Access Compliance Report

Public Rights-of-Way

Intersection ID: 14441	Main Street: E_KINGSTON_AV	Cross Street: SPRINGDALE_AV	Location: W
ADA ID: 16684A1E7941	Ramp Type: Directional1	Initial Pass/Fail: Fail	Overall Compliance: No
			Severity Score: 28.75

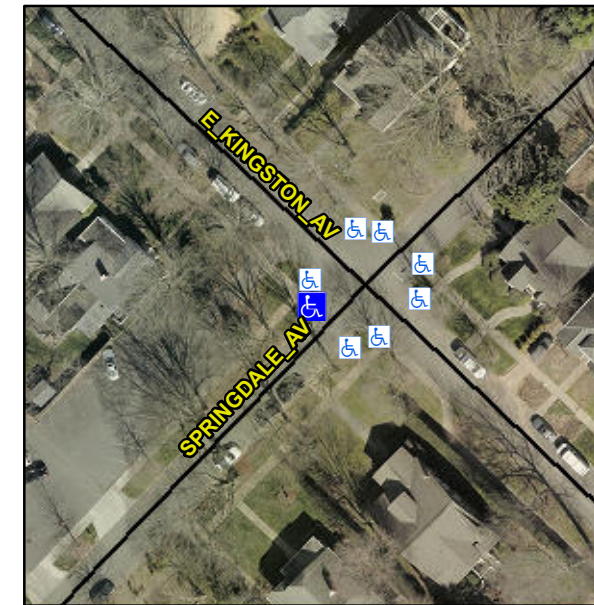
DAMAGED CURB/GTR/RAMP

R304.2.2, R304.5.3, R302.7

Remove & Replace Entire Ramp.
